PROJECT # 9918

City of Coos Bay Plan Review APPROVED As submitted Per correction letter 12-17-99

5113 PORTLAND ROAD N.E. Salem, Oregon 97303 (800) 745-3406	
Customer:		FAMILIAN NORTHWEST	
End User:		FAMILIAN NORTHWEST	
Location:		COOS BAY, OR	
Det. By	Chk By	Date	Scale
TIS		10-19-1999	N.T.S.
Building ID	Job Number	Sheet Number	Issue
A	0801-183342	F1 of 2	0

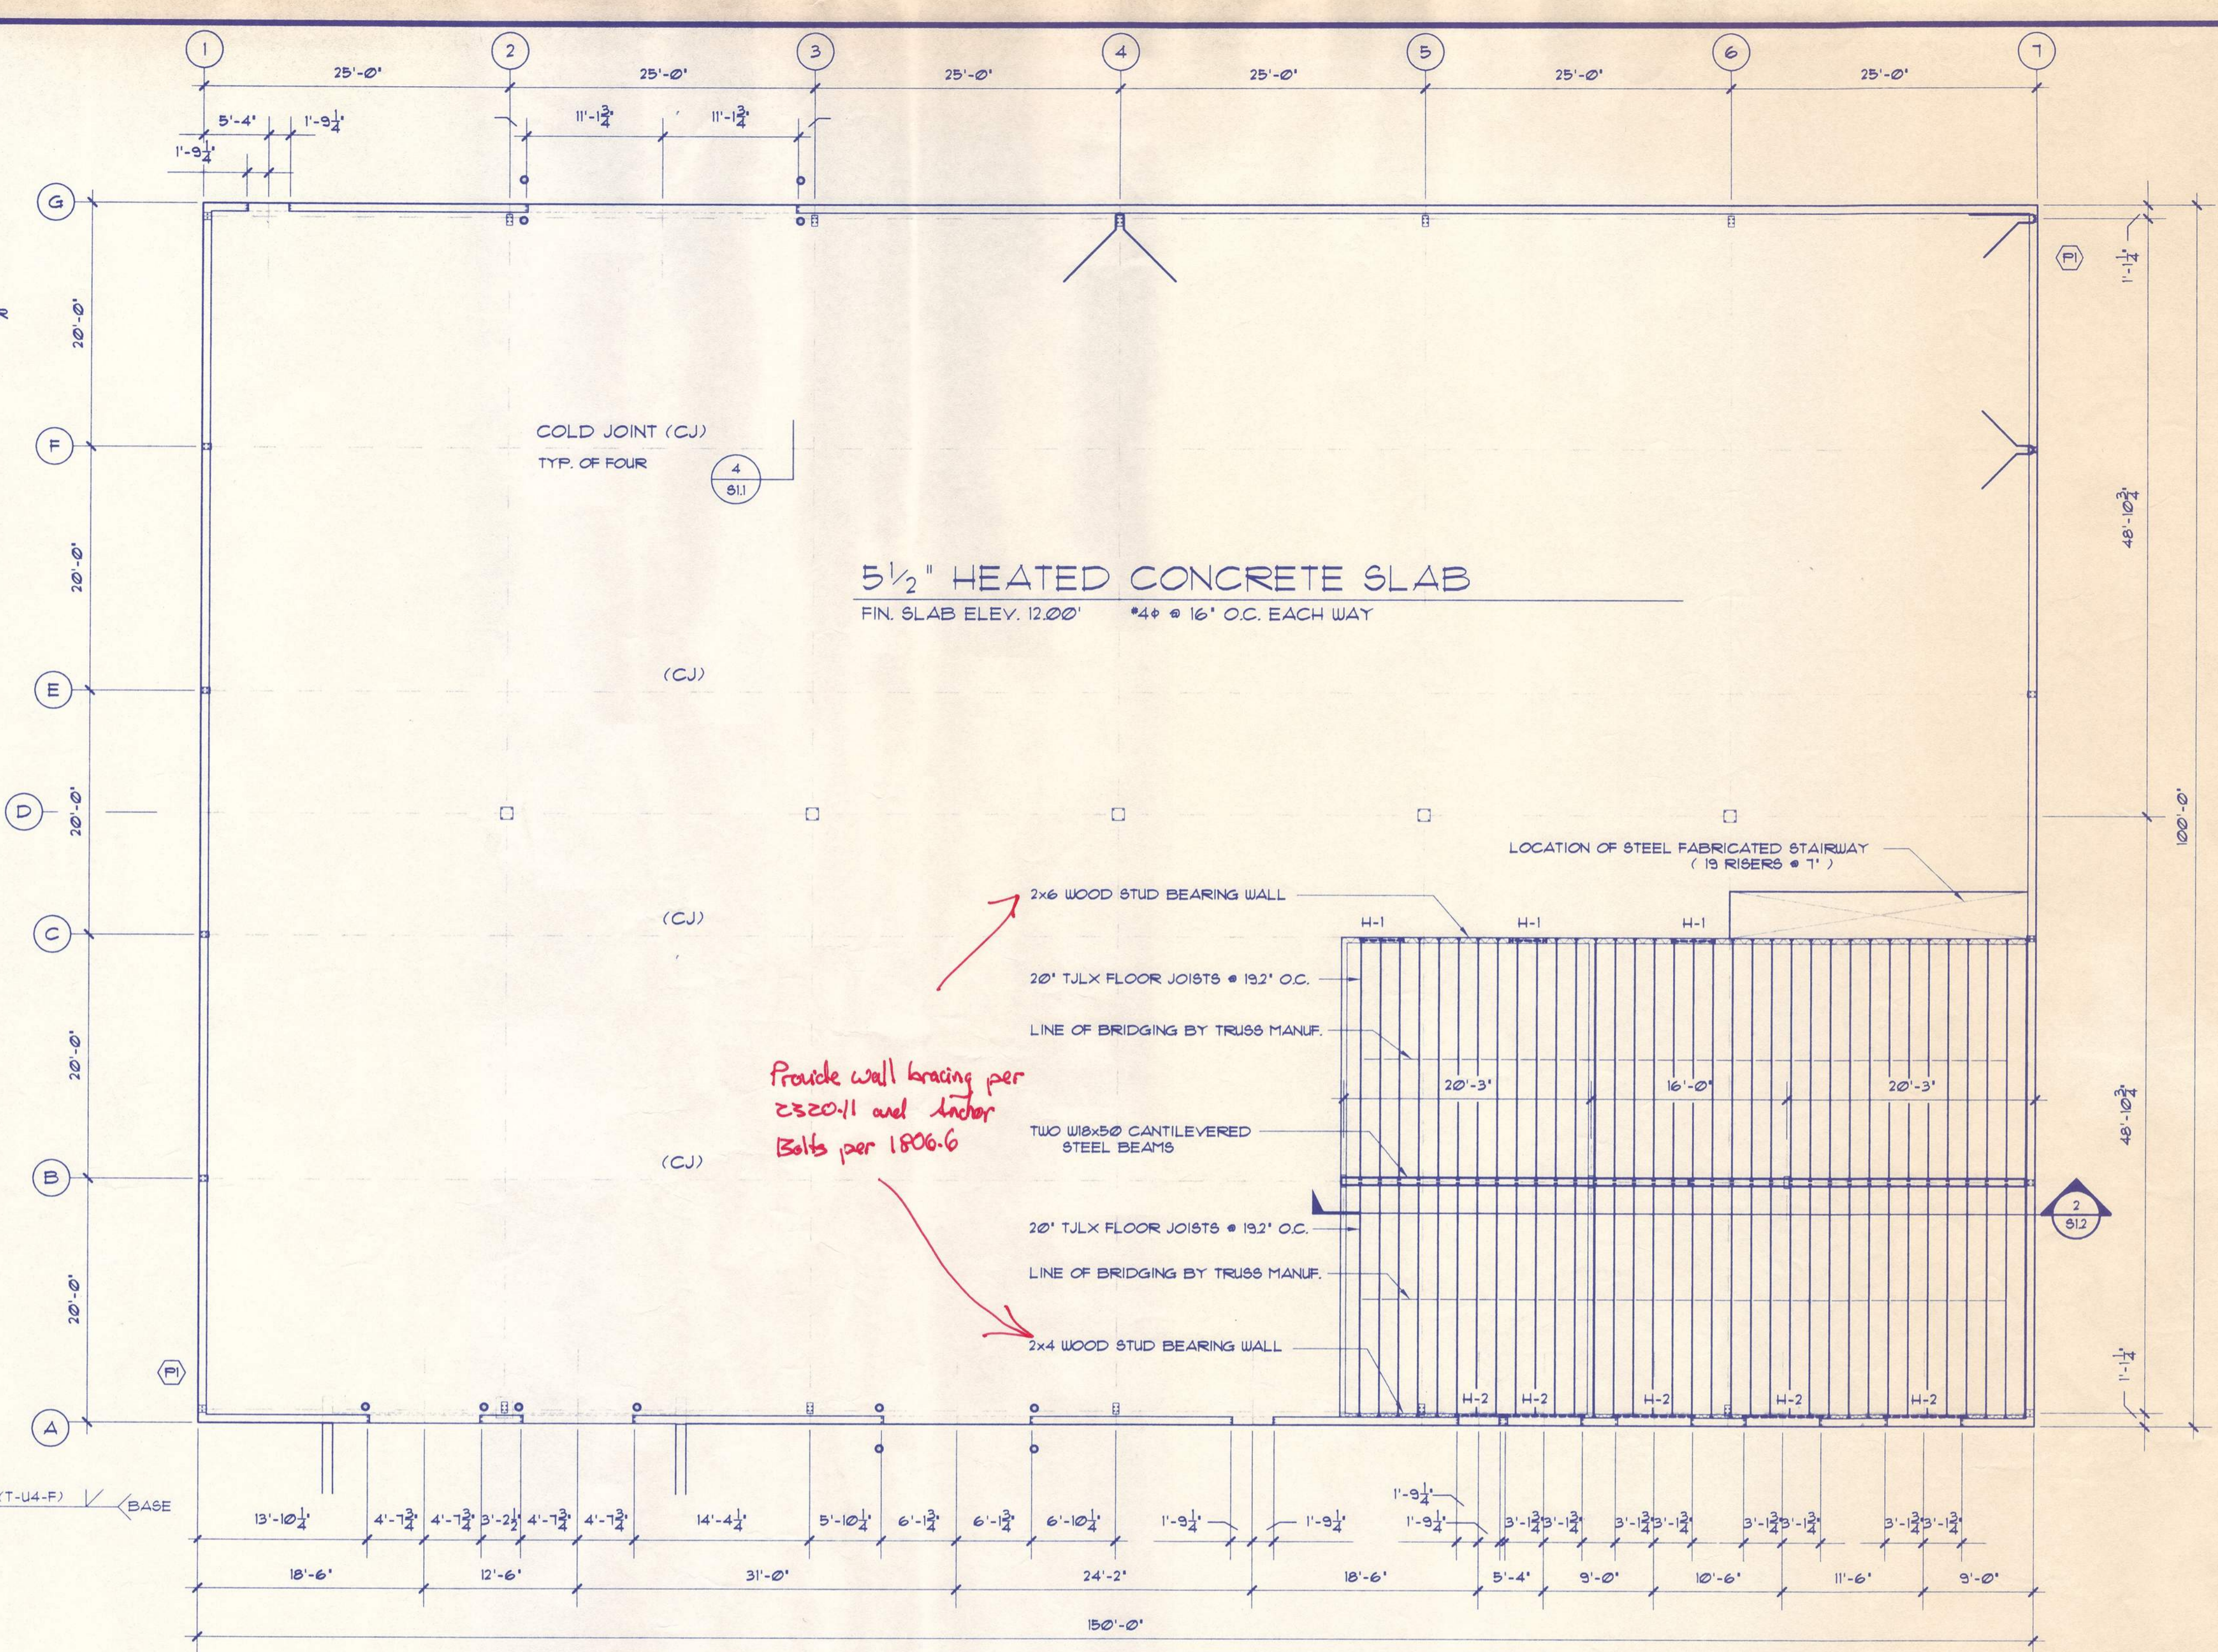
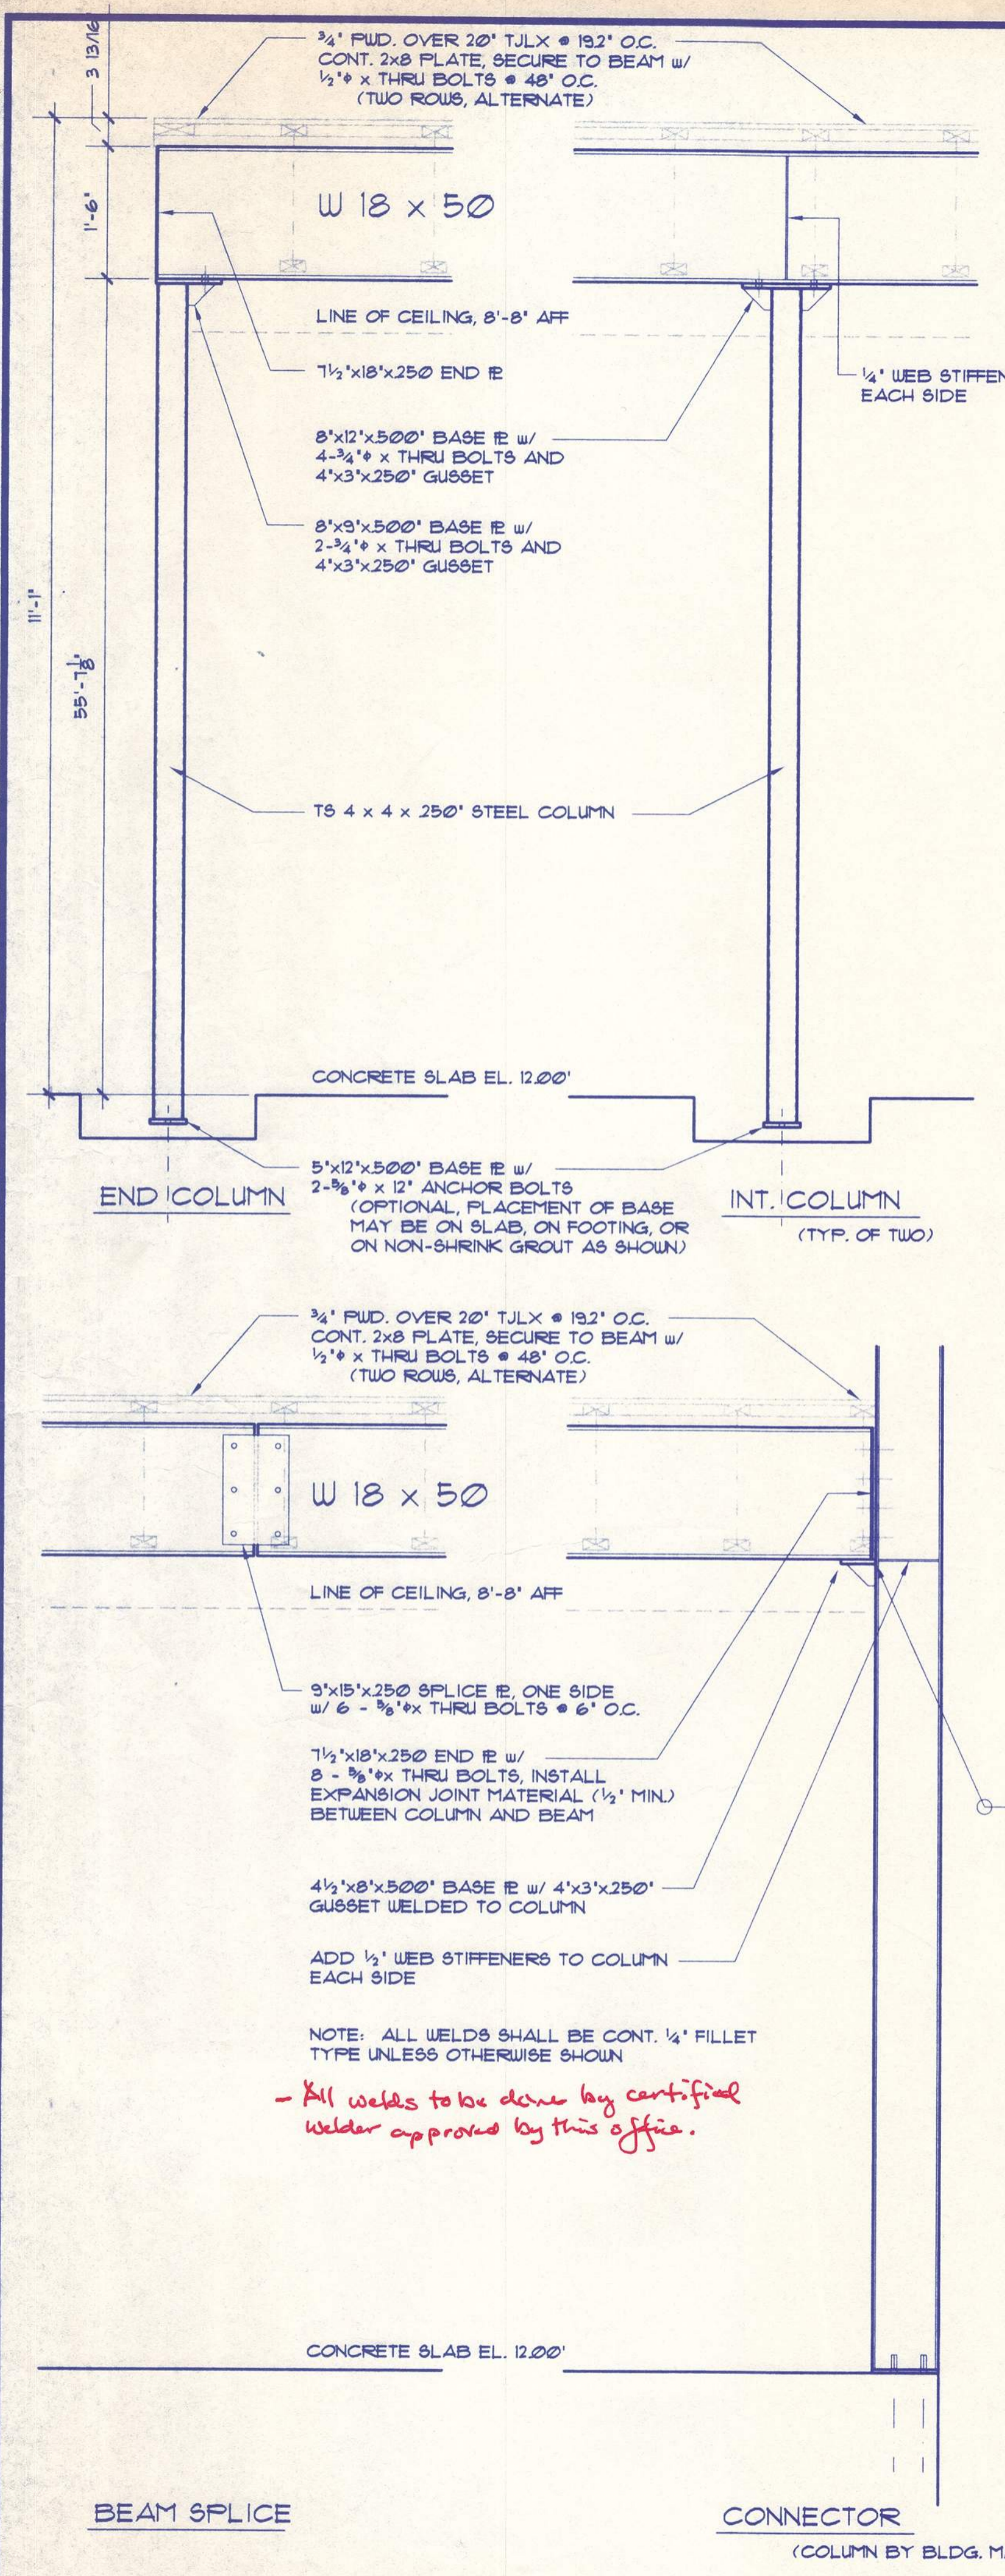
SCALE: 1/8" = 1'-0"
Special Inspection Required!

PLUMBING FLOOR PLAN

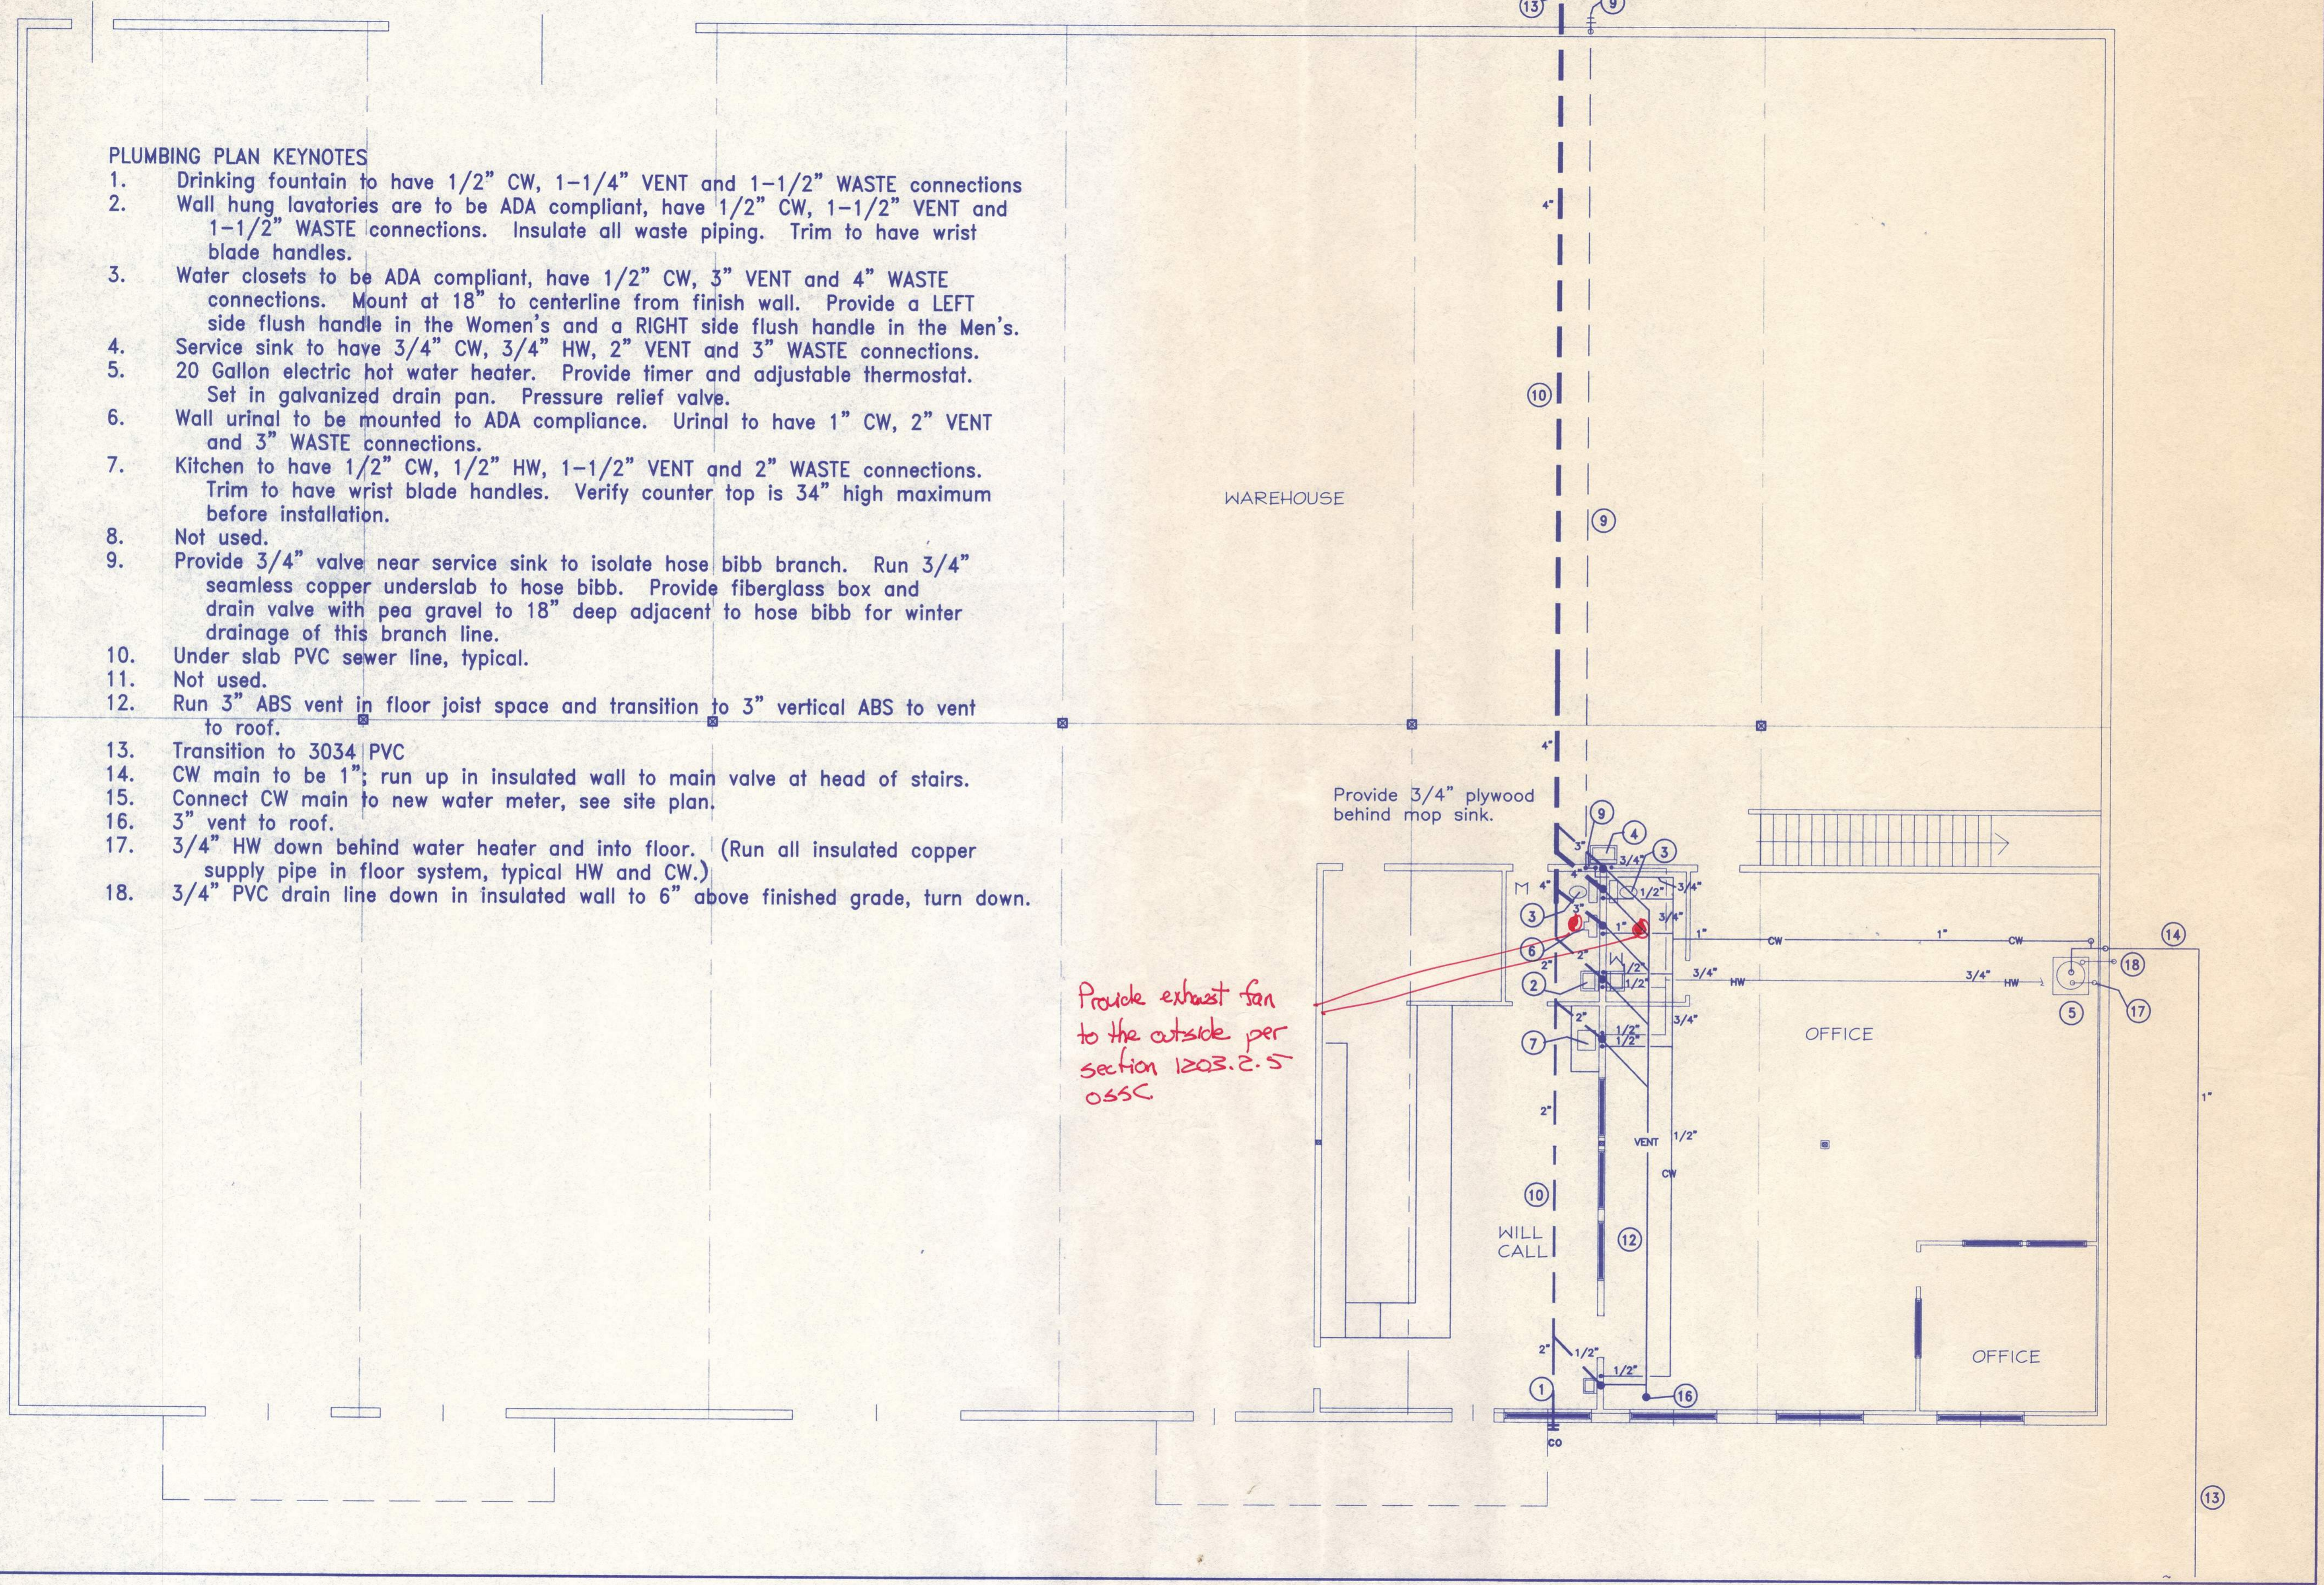
Provide 3/4" plywood behind mop sink.

Provide exhaust fan to the outside per section 1203.2.5 OSSC
